CITY OF KIRKLAND
Planning and Community Development Department
123 Fifth Avenue, Kirkland, WA 98033 425.587-3225
www.ci.kirkland.wa.us

MEMORANDUM

Subject: Lake Washington High School Master Plan and Planned Unit Development (PUD),
ZON07-00035 and APL08-00005

File: Lake Washington High School Master Plan and Planned Unit Development (PUD),
ZON07-00035

Building Height Calculations
Lake Washington High School
Master Plan & PUD Submittal
15 February 2008

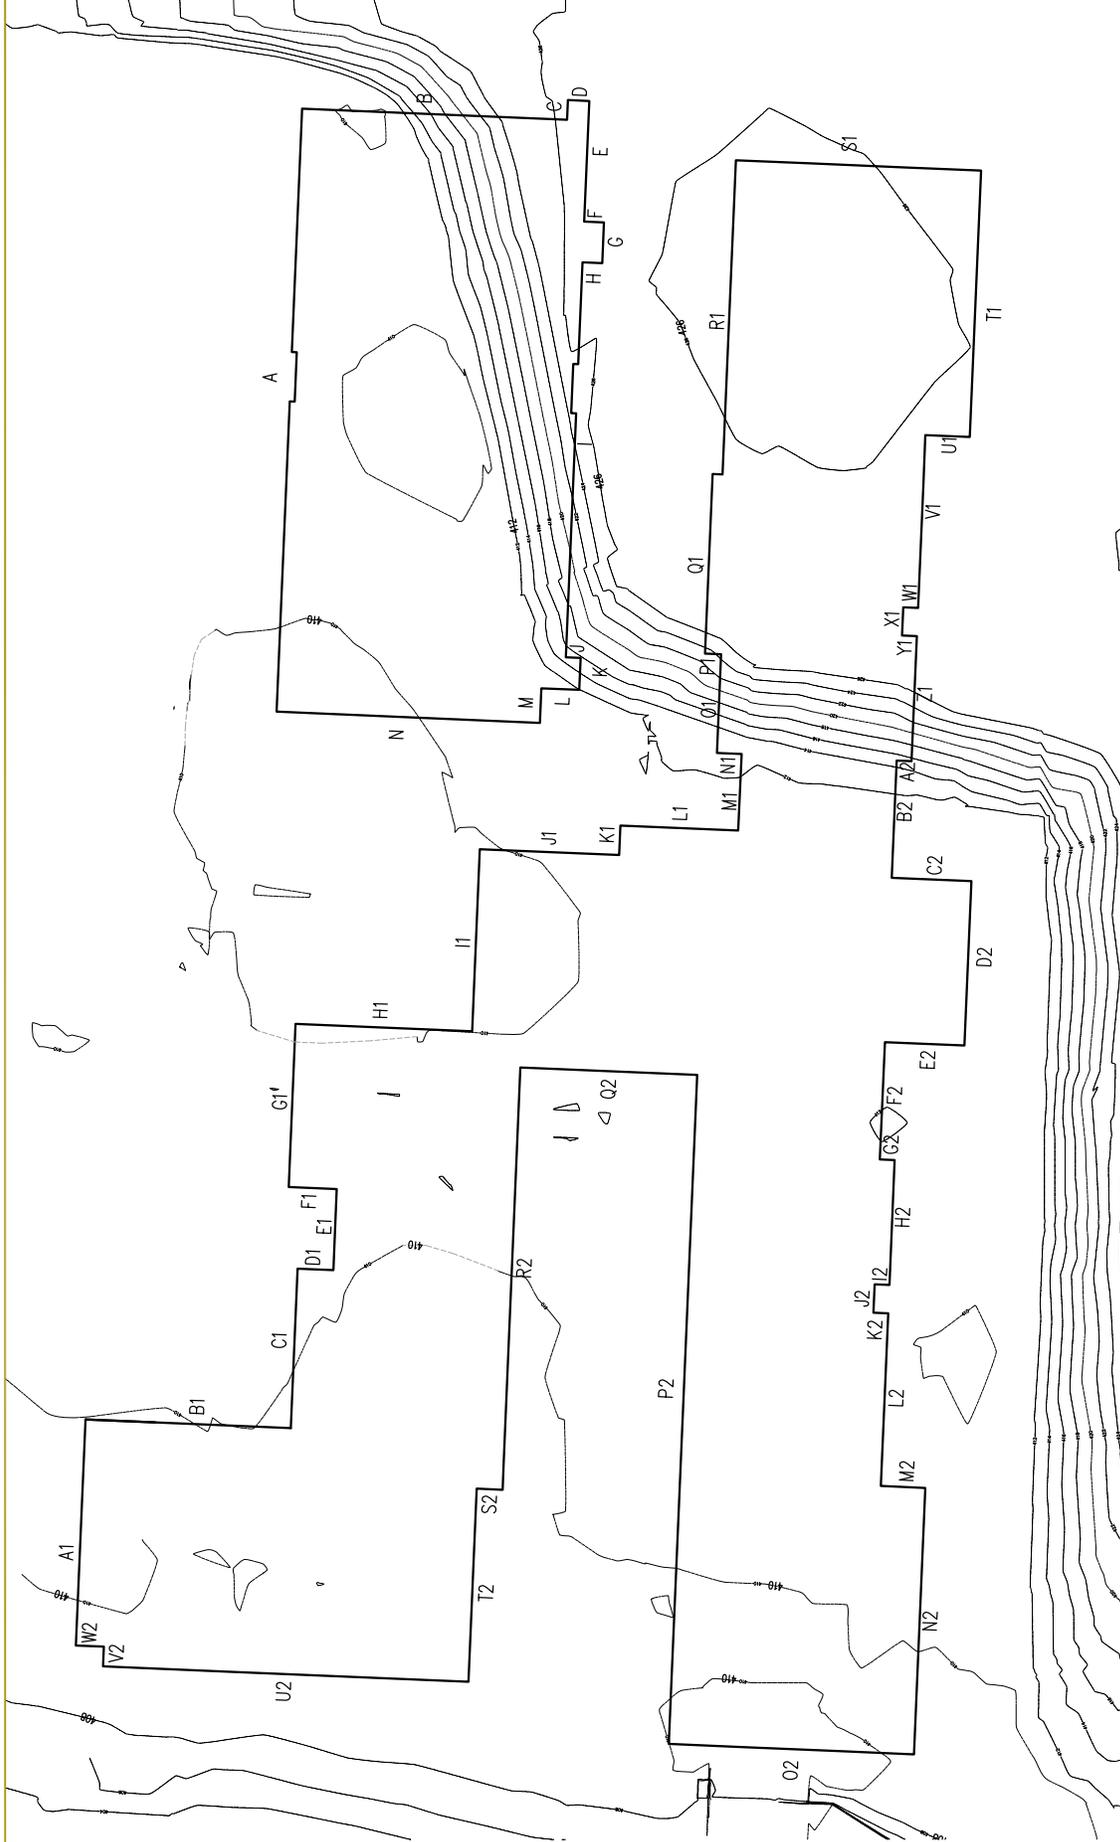
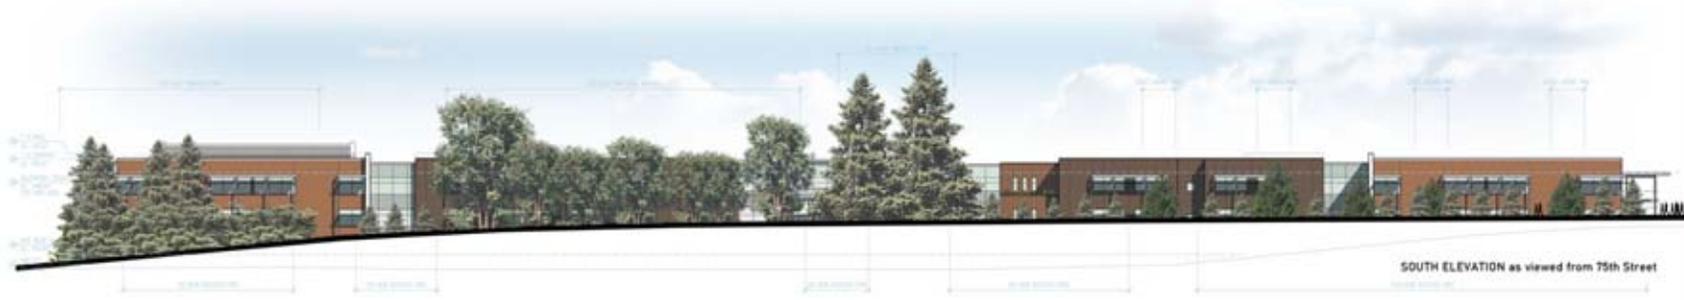
- (2) The applicant is requesting to increase the maximum allowed height from 35 feet to 49 feet through the Planned Unit Development Review Process (see Section II.F.2). In order to get a base height of 35 feet, the proposal must comply with the requirements of ZC Section 17.10.030, Special Regulation 12.

- (1) The proposed school use is designed to accommodate 1,340 students.
- (2) The required setback for a school use is 50 feet. In order to increase the maximum height to 35 feet, the required setback is 55 feet. The closest that a proposed structure is to a property line is 73 feet.
- (3) The South Rose Hill Neighborhood Plan does not contain any policies concerning building heights for the area in which the school is located.
- (4) To help mitigate potential impacts of the increased height the applicant proposes increased setbacks, building modulations, and compatible building materials.

C2.00

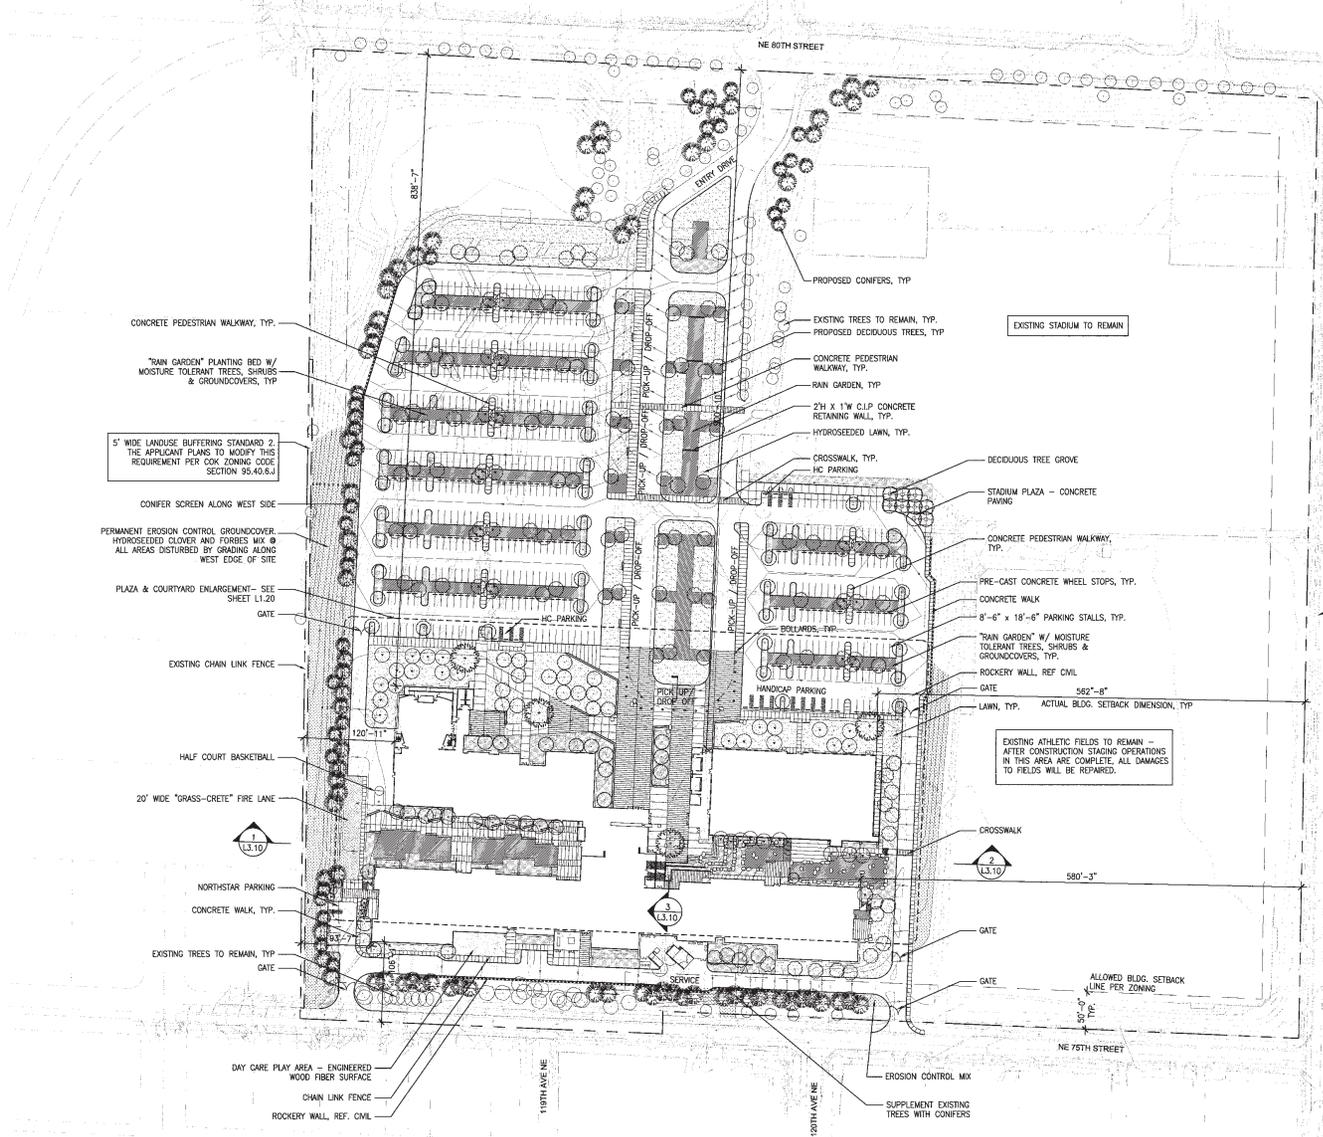
- In the challenge letter, Ms. Fry requests that the Hearing Examiner require that the applicant install additional landscaping along the west property line to mitigate potential impacts of the proposed building. Due to the fact that the Hearing Examiner has already made a recommendation, the City Council could either direct that this issue be considered at a reopening of the hearing before the Hearing Examiner, require modification of the application for the installation of additional landscaping, or deny the challenge.

5' WIDE LANDUSE BUFFERING STANDARD 2. THE APPLICANT PLANS TO MODIFY THIS REQUIREMENT PER COV. ZONING CODE SECTION 95.40.6.J

- b. Conclusions: Pursuant to KZC Section 95.10, the applicant should install a landscape buffer along the west property line that complies with KZC Section 95.40.4. This requirement could be modified pursuant to requirements of KZC Section 95.40.6.j.
